# Susitna-Watana Hydroelectric Project Document

<b>Title:</b> Comments on the Alaska Energy Authority's Initial Study Report, 2014 technical memorandum, and supplemental filings and recommended proposed modifications, Susitna-Watana Hydrologic Project No. 14241-000		<h1>SuWa 294</h1>
<b>Author(s) – Personal:</b> Mike Wood (Susitna River Coalition)      Whitney Wolff (Talkeetna Community Council) Judy Price (Alaska Survival)              Ellen Wolf (Talkeetna Defense Fund) Ryan Schryver (Alaska Center)              Sam Snyder (Trout Unlimited) Emily Anderson (Wild Salmon Center)		
<b>Author(s) – Corporate:</b> (see list above)		
<b>AEA-identified category, if specified:</b>		
<b>AEA-identified series, if specified:</b>		
<b>Series (ARLIS-assigned report number):</b> Susitna-Watana Hydroelectric Project document number 294	<b>Existing numbers on document:</b> 20160623-5174 (FERC posting)	
<b>Published by:</b>	<b>Date published:</b> June 23, 2016

**RE: Comments on the Alaska Energy Authority's Initial Study Report, 2014 Technical Memorandum, and Supplemental Filings and Recommended Proposed Modifications, Susitna-Watana Hydrologic Project No. 14241-000.**

**Figure 2. River stage at the proposed Watana Dam site for the pre-Project and maximum load following OS-1 scenario.**

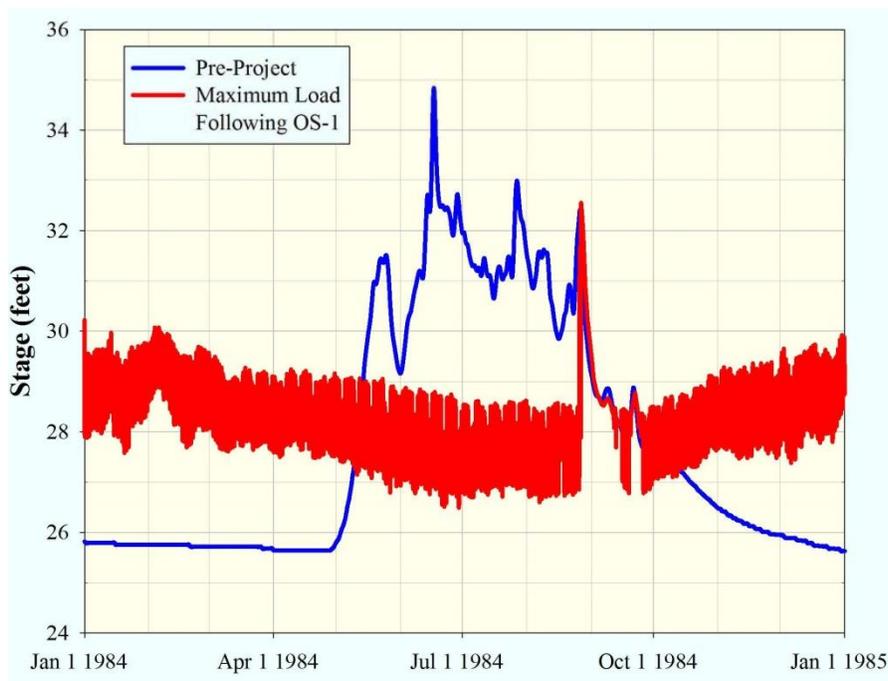
*Comment: Small head differences in groundwater and surface water elevation will drive changes in upwelling and downwelling. Although the primary objective of the model is to understand how Project operations might change these patterns of upwelling and downwelling, at this point, the current model does not appear to have the ability to simulate these small differences effectively. This could become a particular problem when simulating operational conditions, since the transient river stages could oscillate by multiple feet over sub-daily timescales (see Figure 2).*

**Figure 3. Baseline flows in the Middle Susitna River, from the U.S. Geological Survey (USGS) data.**

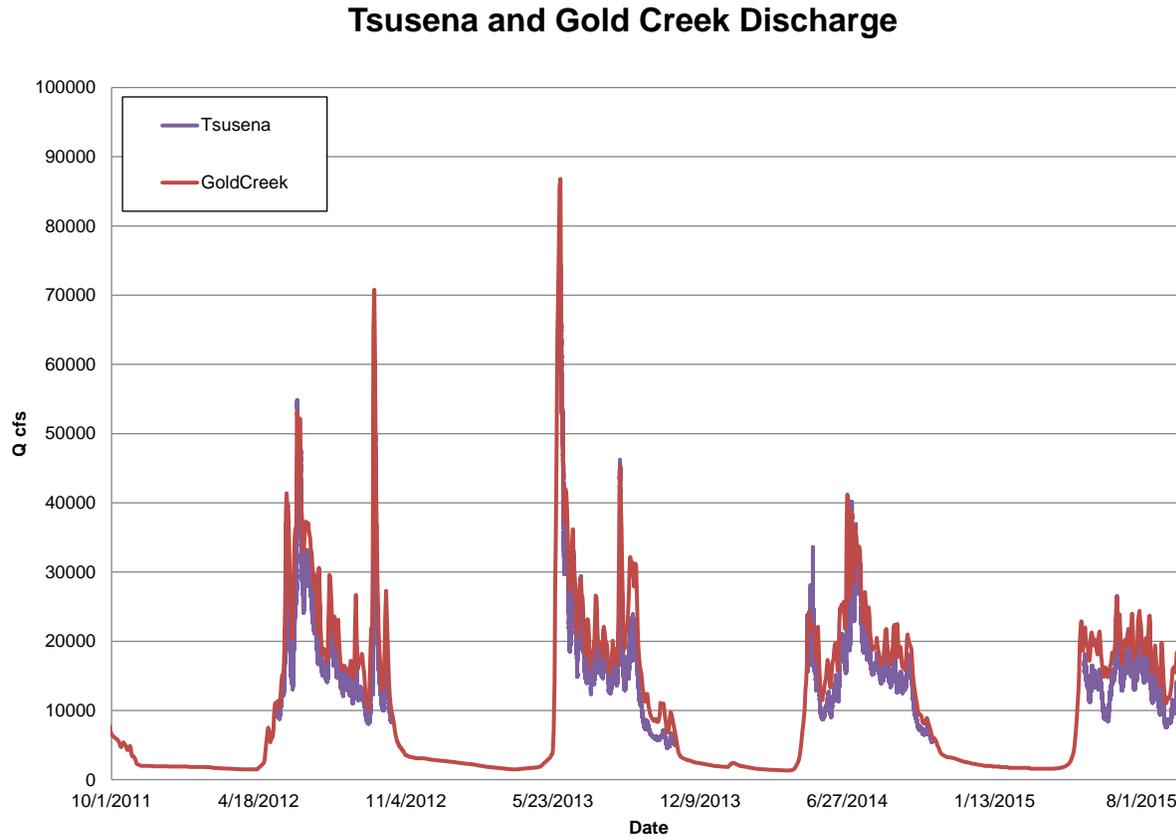
*Under pre-Project conditions, the majority of the winter hydrograph in the Middle River is between ~ 1,000 and 4,000 cfs (see Figure 3), which is substantially lower than 6,200 cfs. This winter low flow period is when salmon eggs are incubating, primarily in off-channel habitats. Future regulated flows will greatly alter this hydrologic regime, so that winter flows will be closer to 5,000–10,000 cfs. A key question regarding impacts on salmonids is how off-channel habitats will be affected by these higher winter flows. The lack of baseline aerial imagery for current winter flow conditions may influence AEA’s ability to evaluate proposed Project habitat changes from current winter conditions throughout the Middle River.*<sup>24</sup>

Because AEA does not have complete aerial photography coverage for the lowest flow proposed in the approved study plan, it is difficult to evaluate how dam-induced changes in flow will influence habitats throughout the Middle River. Under pre-Project conditions, the majority of the winter hydrograph in the Middle River is between ~ 1,000 and 4,000 cfs (see Figure 3), which is substantially lower than 6,200 cfs.

Figure 4. Sediment rating curve for Susitna River at Gold Creek.

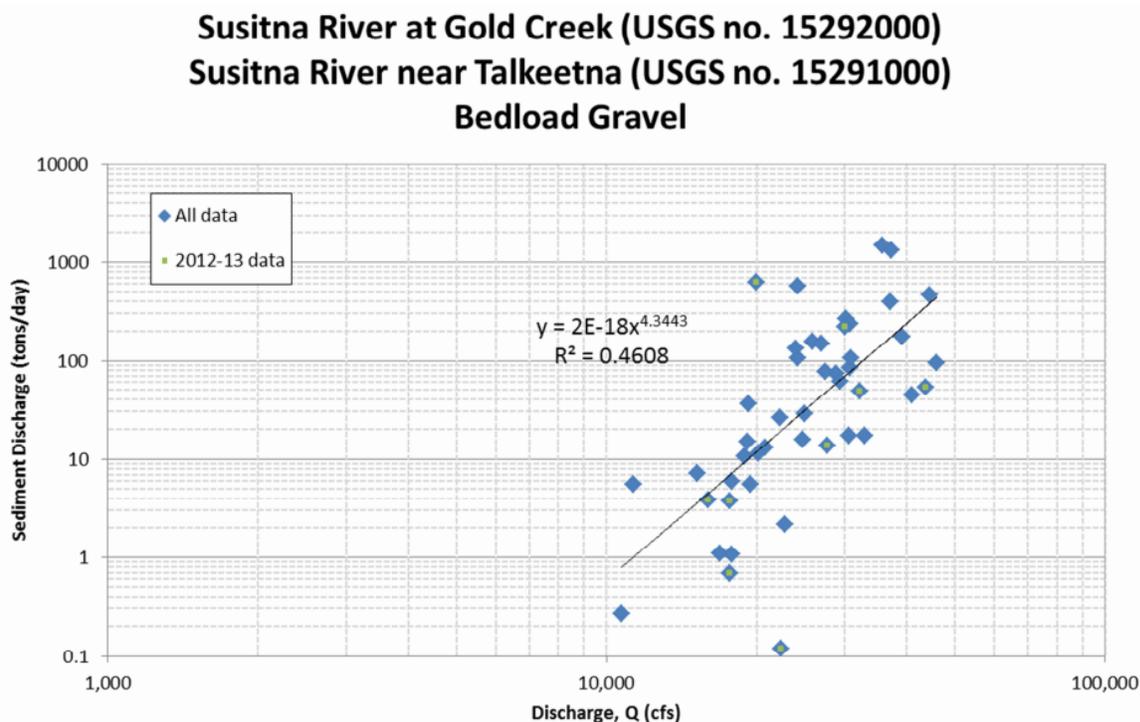
*Comment: Total sediment load will depend much more on peak runoff than on total runoff. Bed load gravel transport in the Middle Susitna River largely occurs between 20,000 and 40,000 cfs (see Figure 4); scenarios based on total annual runoff may not capture this bed load transport efficacy.*

Figure 5. AEA’s conceptual framework for integration of habitat-specific models and riverine processes, presented in ISR Study 8.5.

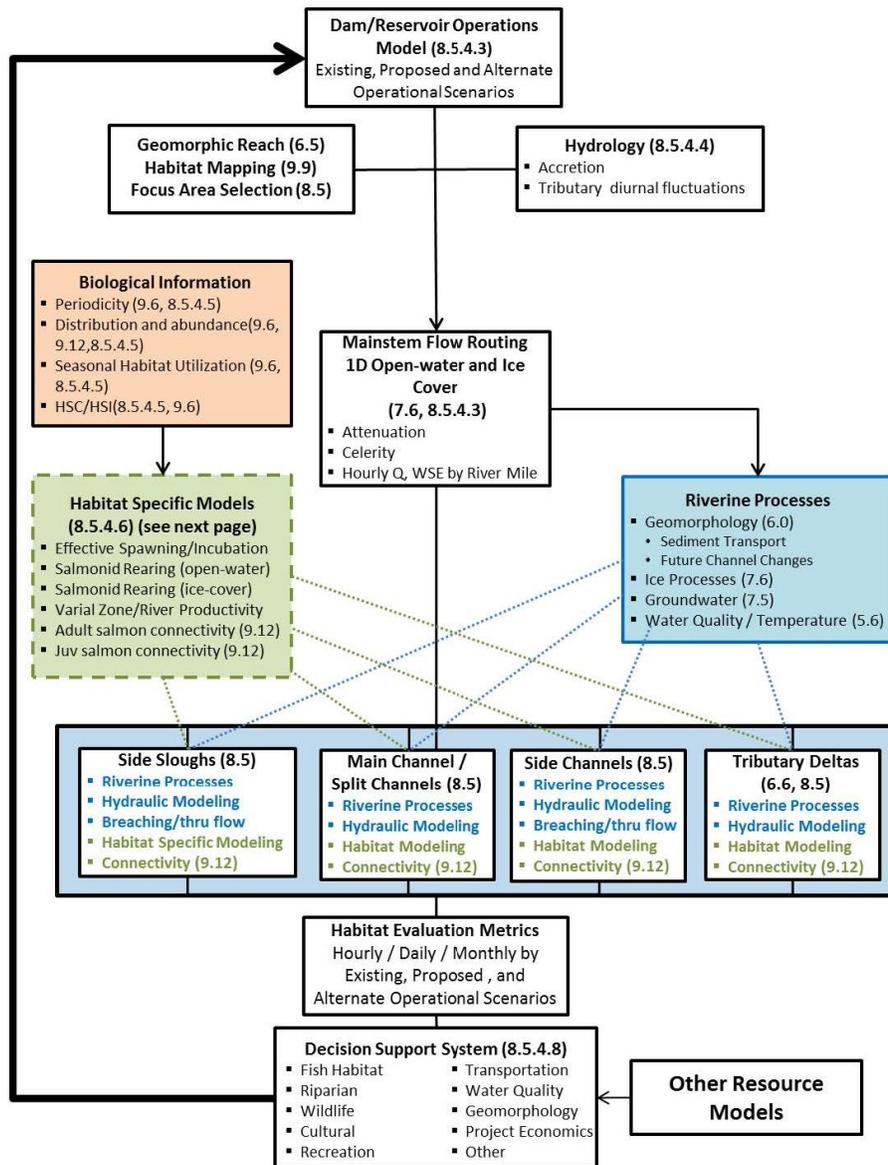
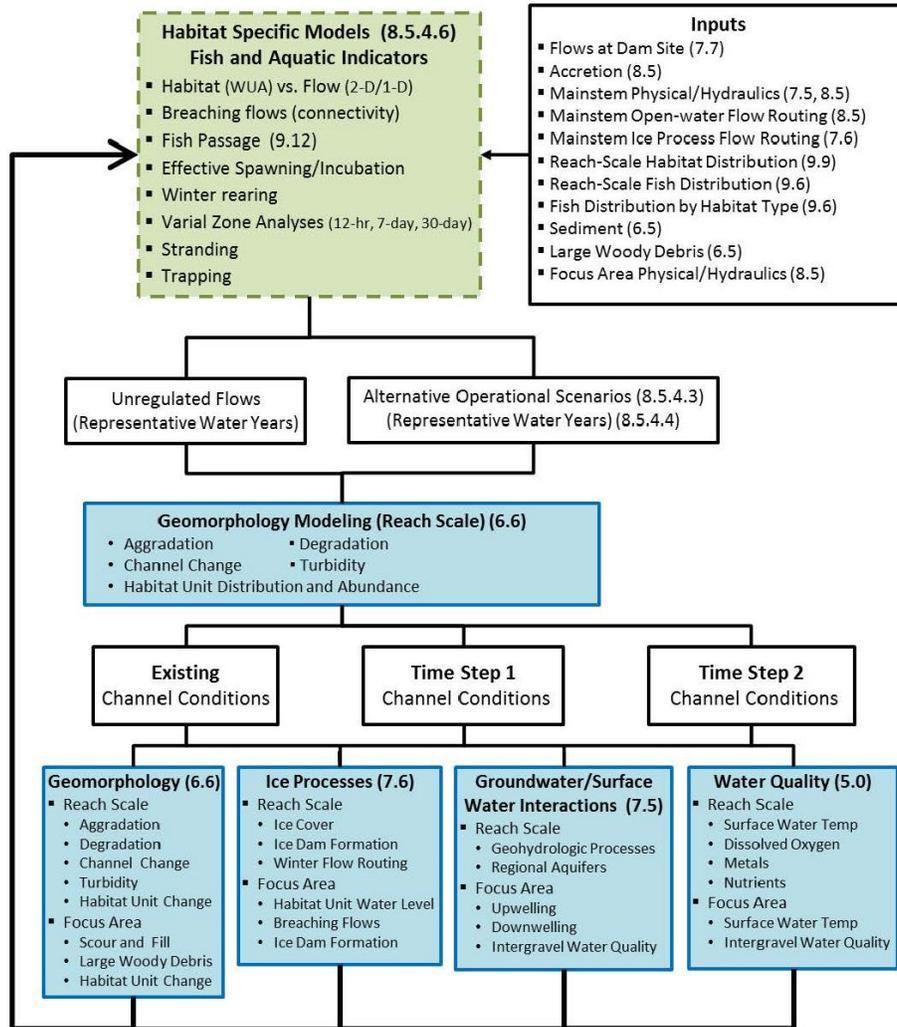
*Comment: These diagrams are the primary modeling flow charts, which guide all studies, modeling, and evaluations. These flow charts are poorly conceived and conceptualized. SIR Figures 4.1-1a (Figure 5) and 4.1-1b (Figure 6) are confusing and their meaning is not well-described in the text. Specific comments are as follows:*

1. *In Figure 4.1-1a, it is unclear why the dam operational scenarios do not feed directly into the open-water flow model. For example, AEA needs to clarify how the geomorphic reach (6.5) habitat mapping (9.9) and hydrology models (8.5.4.4) modulate the transition between reservoir operations and open-water flow modeling.*

2. *As depicted in Figure 4.1-1a, open-water flow influences groundwater, but there is no feedback between groundwater and open-water flow modeling. Clearly, river stage will influence groundwater flow, as demonstrated by the one-way arrow from open-water flow to the riverine processes box, but groundwater flow will also influence river stage. AEA needs to clarify how this feedback is being modeled or characterized in the overall modeling framework.*

3. *As depicted in Figure 4.1-1a, there is no feedback between ice processes and open-water flow. Ice formation will influence flow, as will ice breakup. AEA needs to clarify how these feedbacks are being considered in the modeling of flow in the river.*

4. *It is not clear how the flow chart in Figure 4.1-1b relates to the flow chart in Figure 4.1-1a. For example, the white box at the top right of Figure 4.1-1b shows mainstem, open-water flow routing feeding into the green habitat specific model box – yet Figure 4.1-1a shows no such interaction. AEA needs to clarify how and if these modeling components are actually being coupled.*

5. *It is not clear from the flow chart in Figure 4.1-1b which of the parameters listed in the blue boxes are being passed back to the Habitat-Specific Models at the top of Figure 4.1-1b (green box). AEA needs to clarify which parameters are being used, and how each of those parameters is being considered in the habitat models.*

**Figure 7. Example presented in ISR for Study 8.5 showing data dependencies and data flow for effective spawning/incubation analysis in the Middle River FAs**

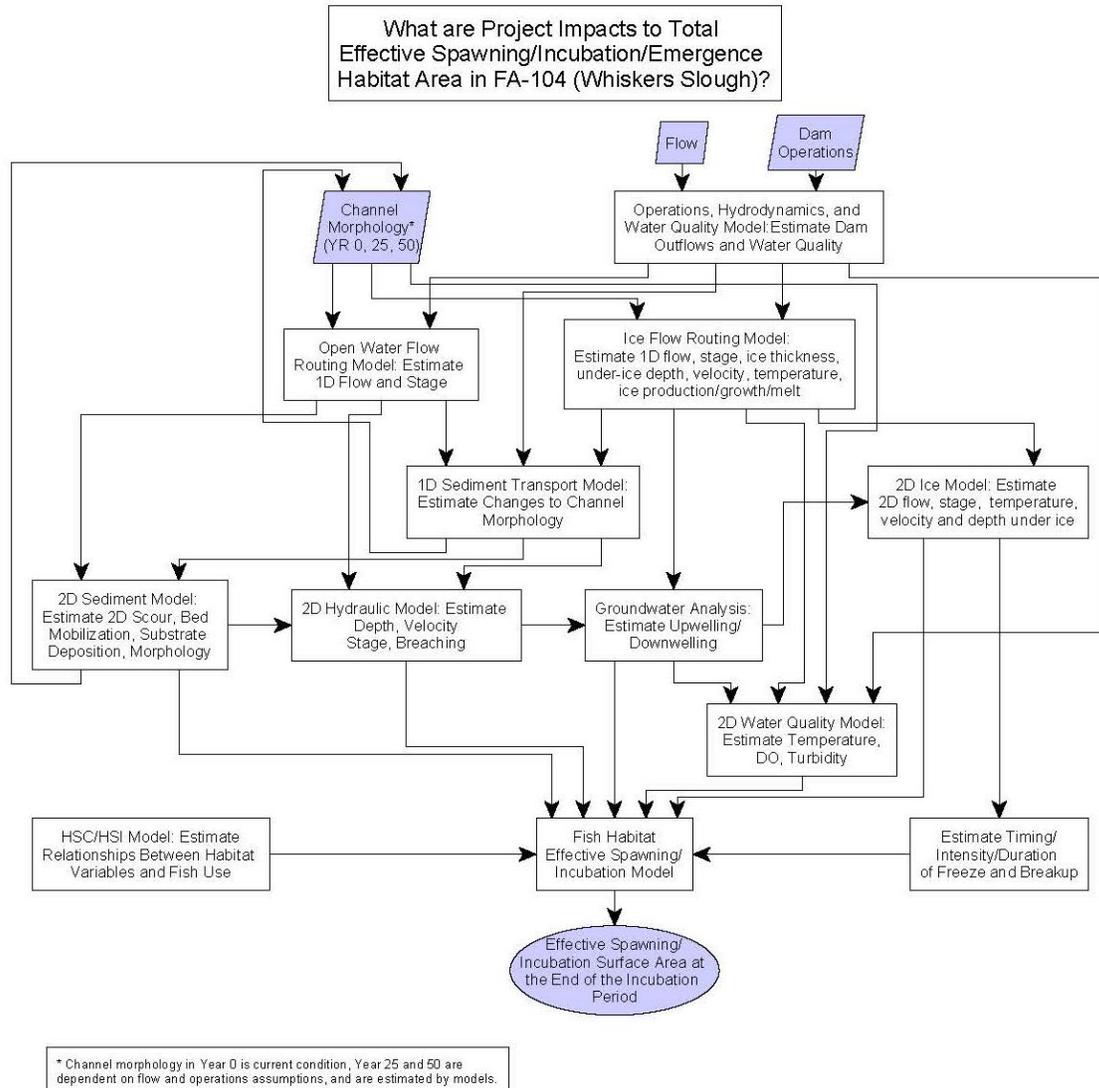
6. *Comment: Figure 5.6-13 from 8.5 IFS ISR, Part A (Figure 7), shows a flow chart of data/models that appear to start with “Flow and Dam Operations” (purple boxes) and end up predicting “Effective Spawning/Incubation Surface Area at the End of the Incubation Period” (a purple ellipse at the bottom). At a minimum, this flow chart should clarify key decisions to be made at every step, clearly describe the inputs/outputs that are being transferred between the various modeling steps, and show how it relates to other important flow charts summarized above. Specific comments on this figure include the following:*

- *Based on Figure 5.6-13, the OWFRM 1-D hydraulic model feeds into the 2-D Sediment Model and 2-D Hydraulic Model, but the 2-D Hydraulic Model does not feed into the 2-D Sediment Model. AEA needs to clarify the interactions between 2-D hydraulics and 2-D sediment transport in their modeling.*

**Figure 8. AEA's presentation of study interdependencies for riparian IFS, presented at the May 29, 2014, TWG meeting.**

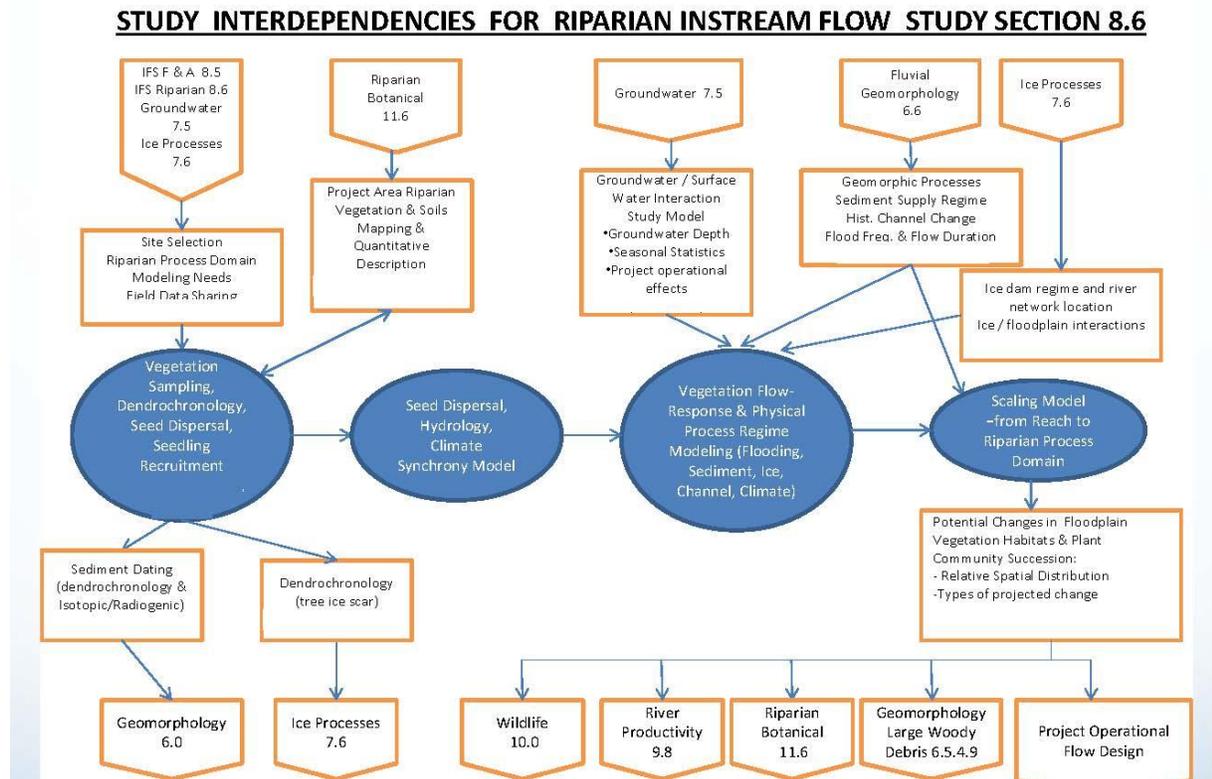
*Comment: Details associated with the flow chart (Figure 8) associated with the April 29–30, 2014 TWG meeting (R2, 2014) below should be significantly revised to more clearly show how data, models, and critical decisions actually feed into each other. It should also be made consistent with other primary flow charts presented above (i.e., Figures 4.1-1a and 4.1-1b in the 8.5 IFS study). These flow charts are critically important for showing all stakeholders how data are used/transferred between studies, and how the various model inputs and outputs are shared. More importantly, these flow charts provide the basis for showing how the most important*
